**ADDENDUM NO. 04**

Issued: May 8, 2020

Project: Maintenance Offices Exterior Circulation Repair  
2220 N. 59th Street, Kansas City, Kansas 66104

Project No. 18002

**D03**

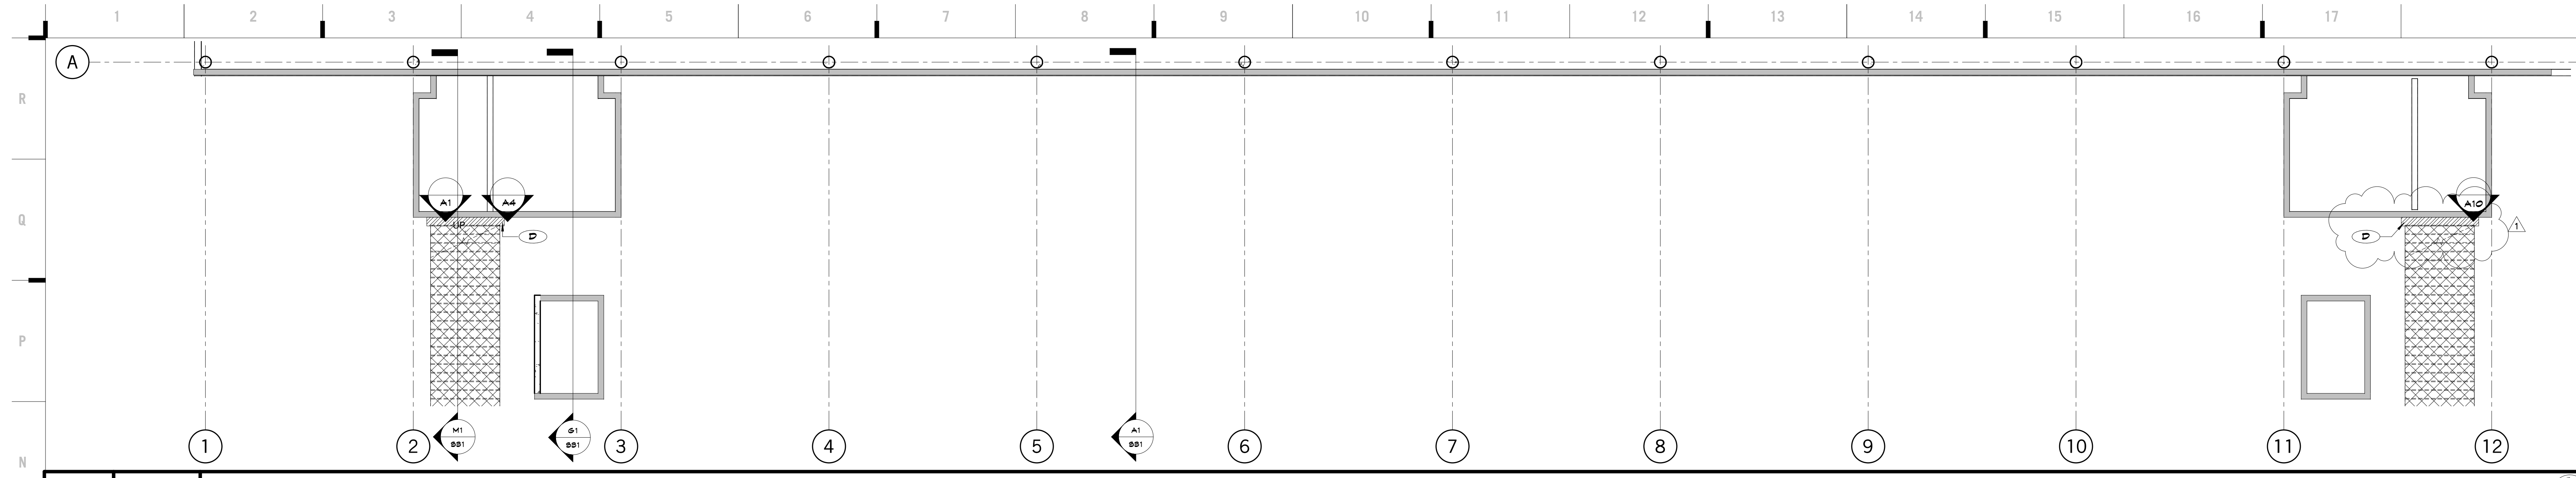
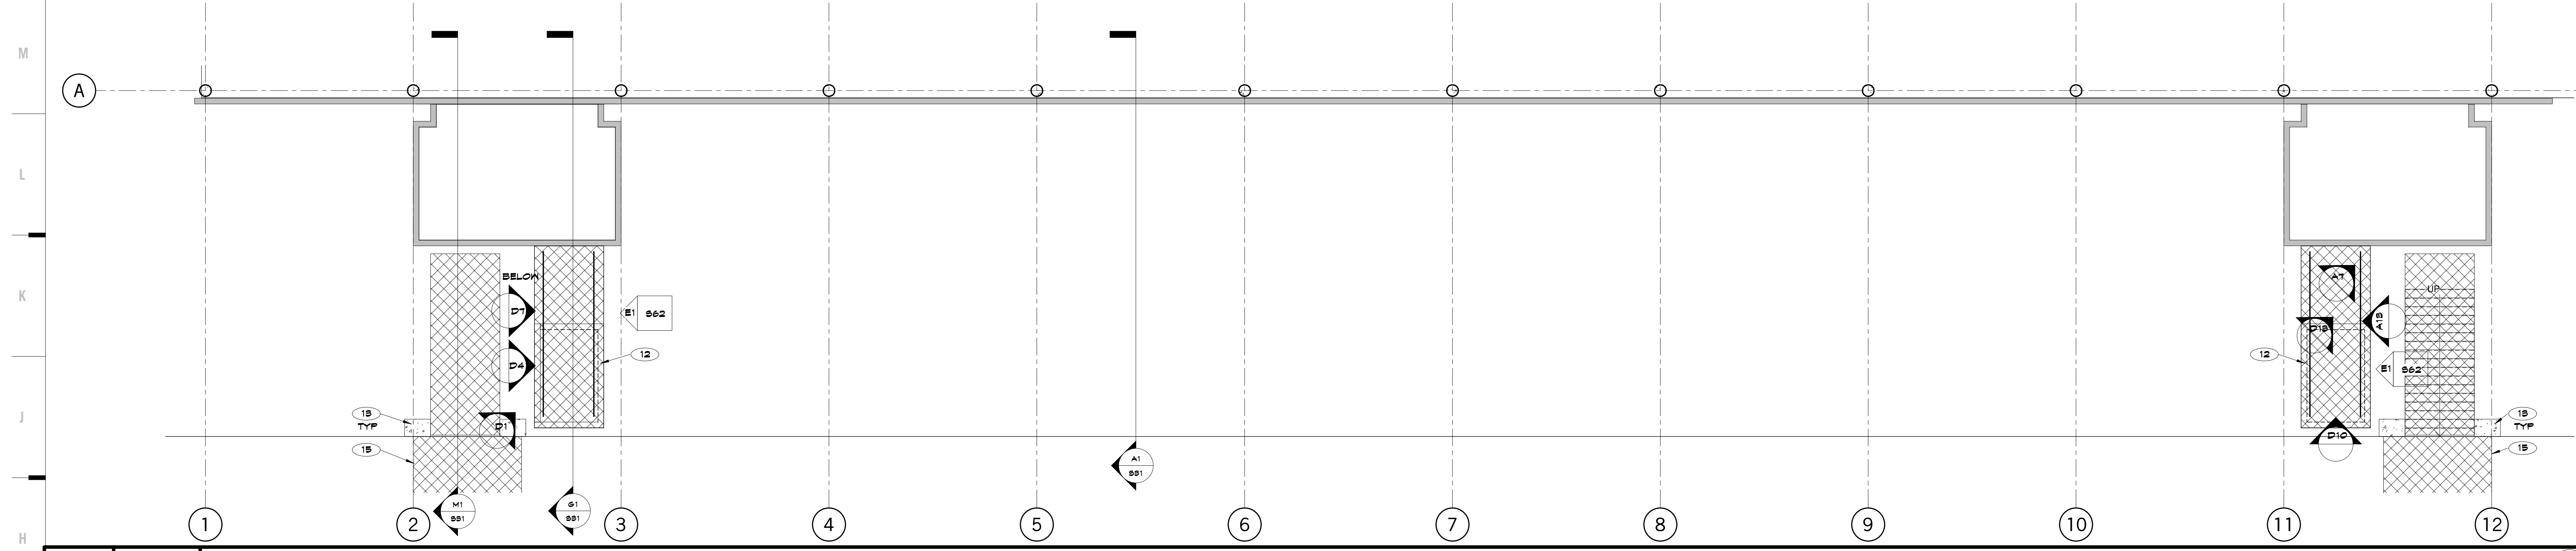
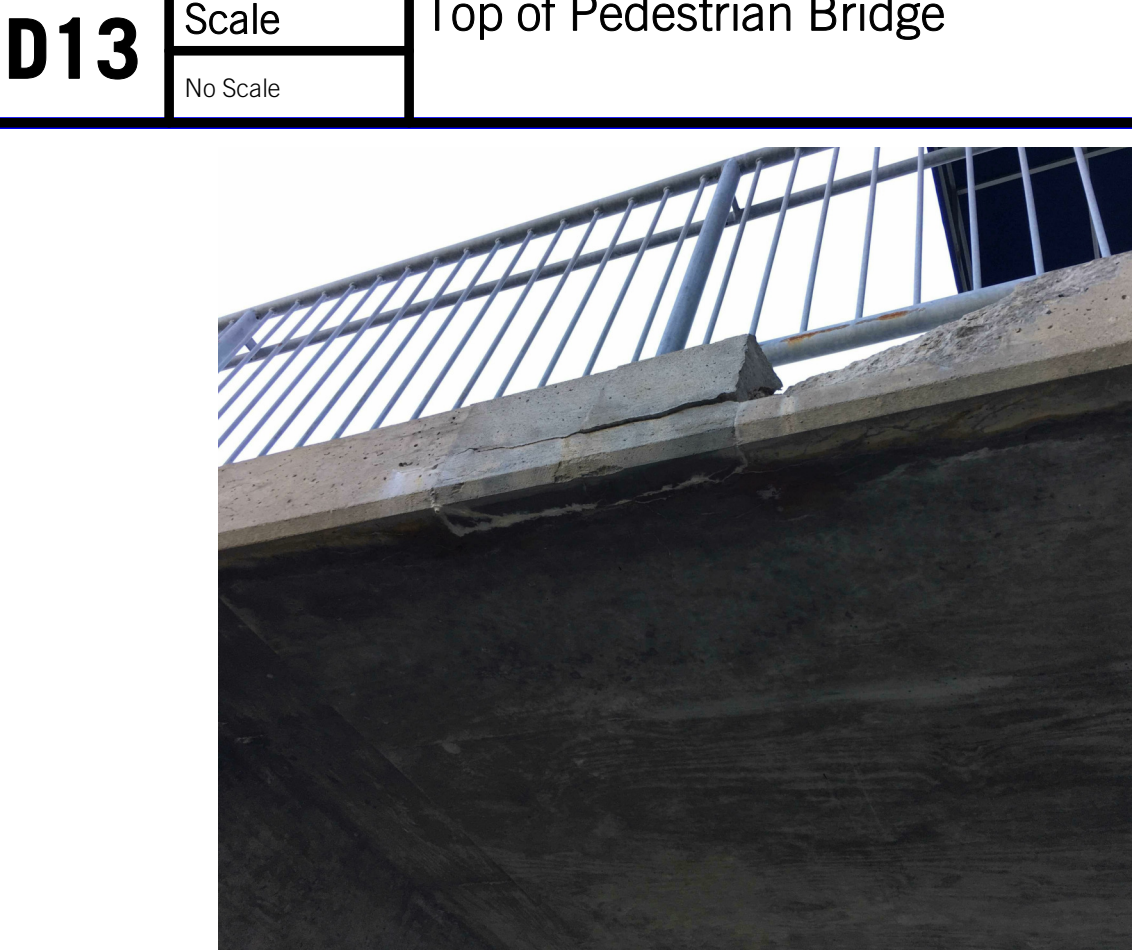
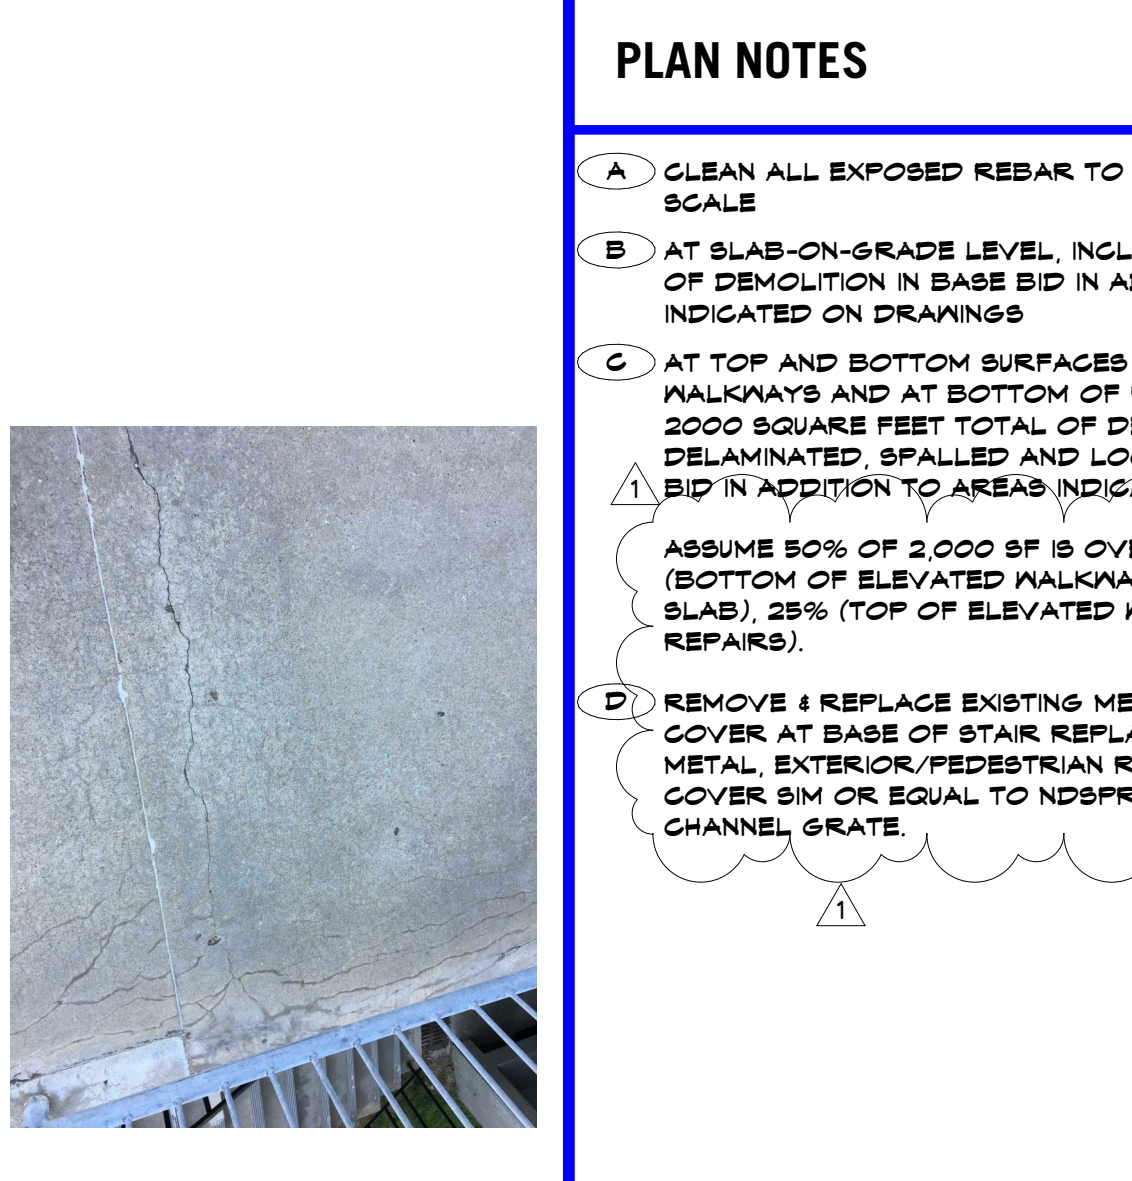
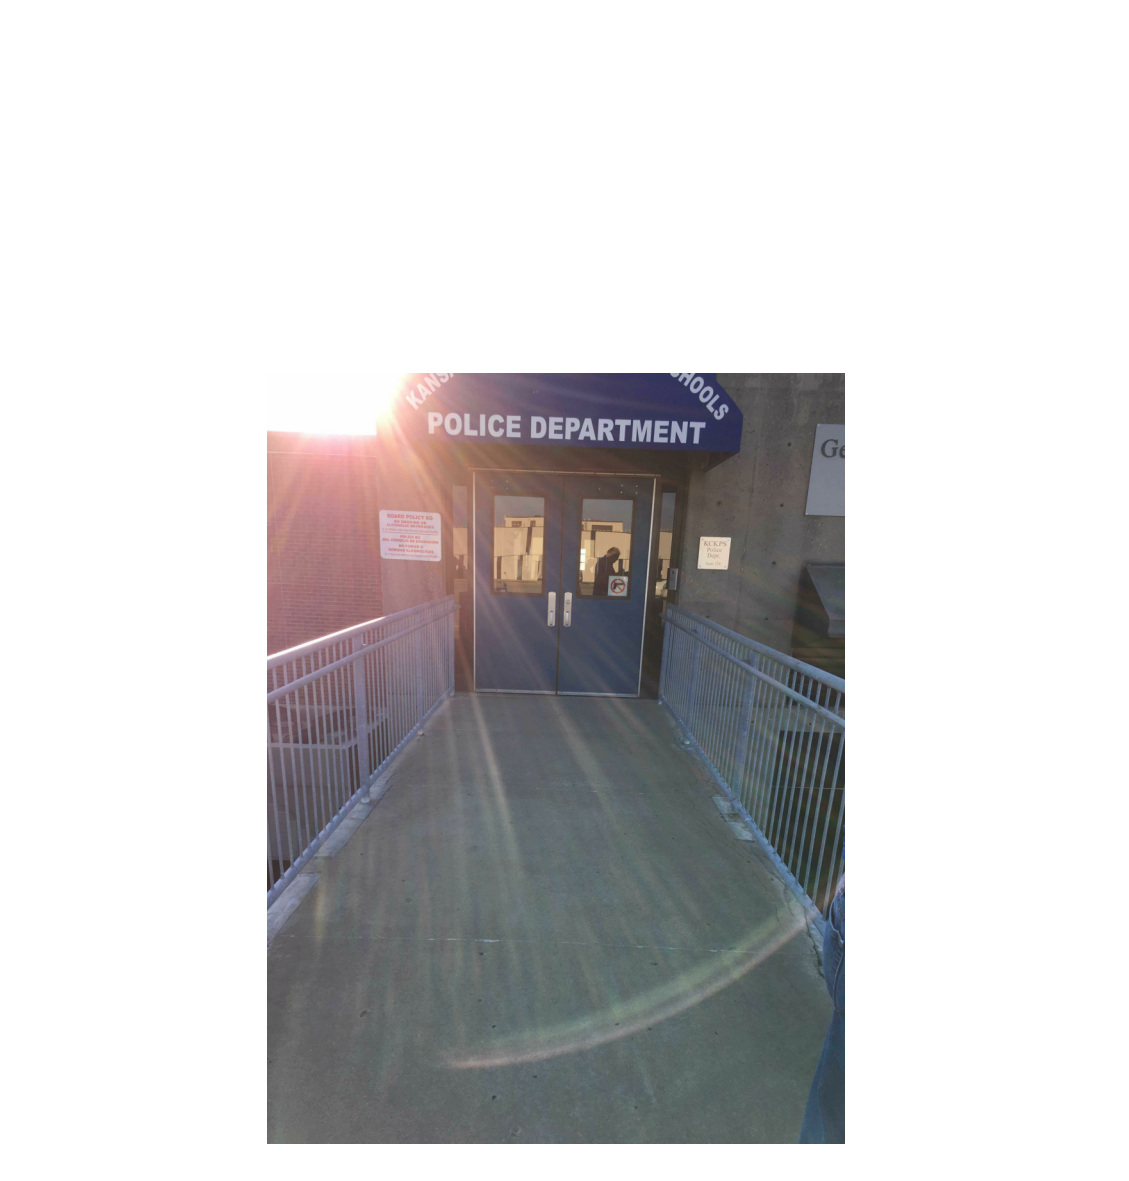
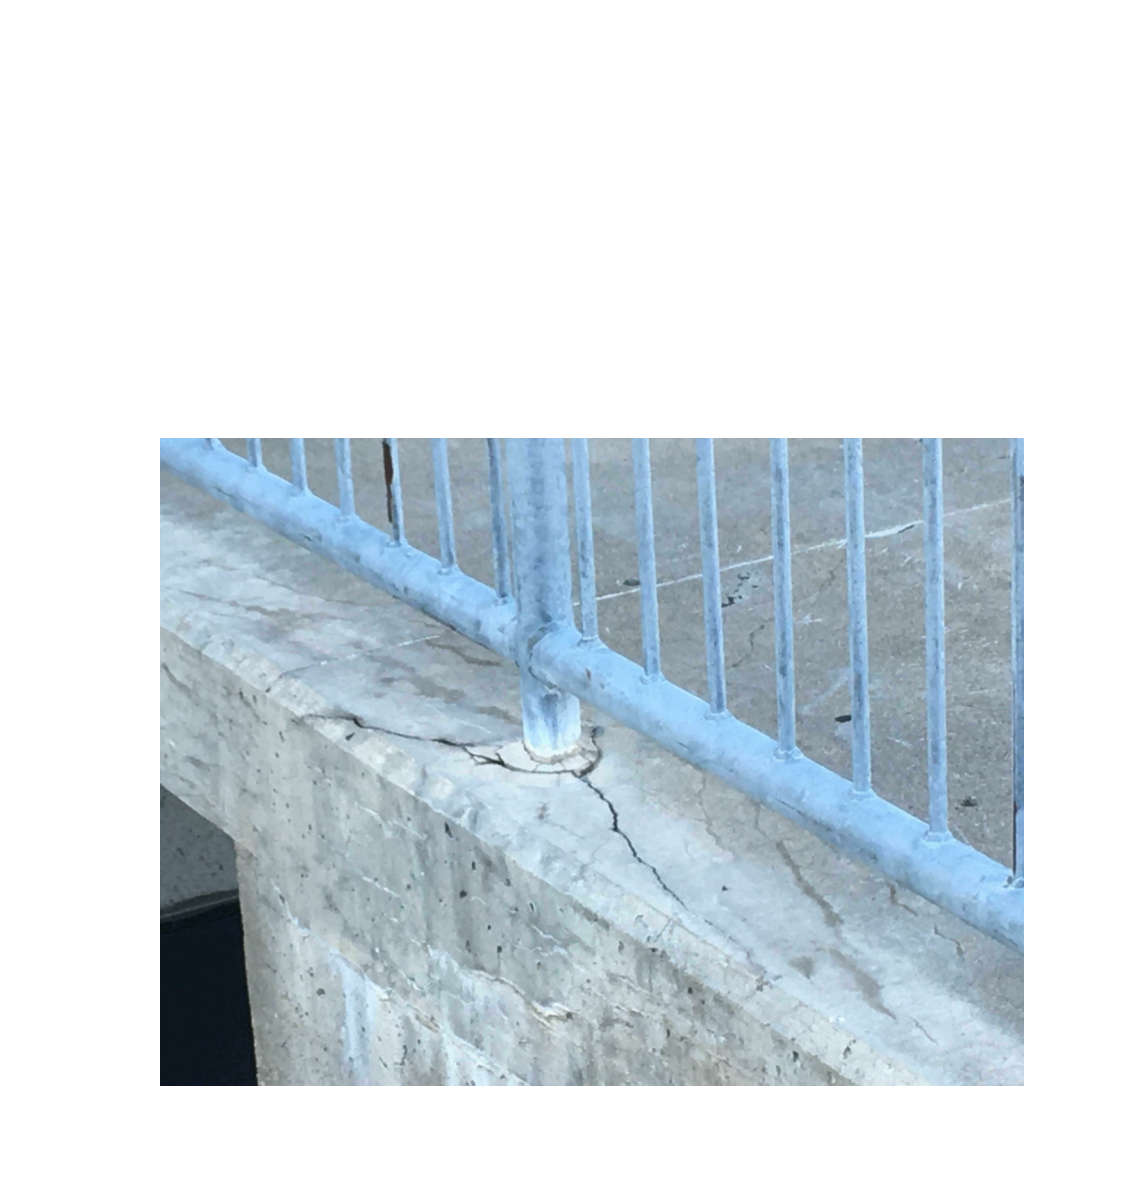
Bid Package No.	Drawing or Specification	Question	Who asked it?	Submission No.	Response
1	Concrete	Bid Set 20200415	Please confirm trench drain Note D on D03 at N1 Gridline 2-3 applies to gridlines 11-12 as well.	JEDSP	1	This will be clarified in Addendum 02.
2	Concrete	Bid Set 20200415	Please confirm concrete repair SOW is responsible for dumpsters within its own scope. Ref Page 01 74 19 Para 3.1 B	JEDSP	1	See Revised Scope of Work included in Addendum 02. The concrete Contractor will be responsible for removal of all concrete, reinforcing and asphalt debris in a separate dumpster as required to complete this Scope of Work.
3	Concrete	Bid Set 20200415	Please confirm trench drain cover will be supplied by the misc. steel SOW and installed by the Concrete SOW. See D03, Plan Note - D	JEDSP	1	Confirmed.
4	Concrete	Bid Set 20200415	Pease confirm is it acceptable to use drill and epoxy bolts similar to page S32 detail E1 in lieu of the typical core drill and grout at pipe posts.	JEDSP	1	Bid project per details as documented. Different conditions require different details.
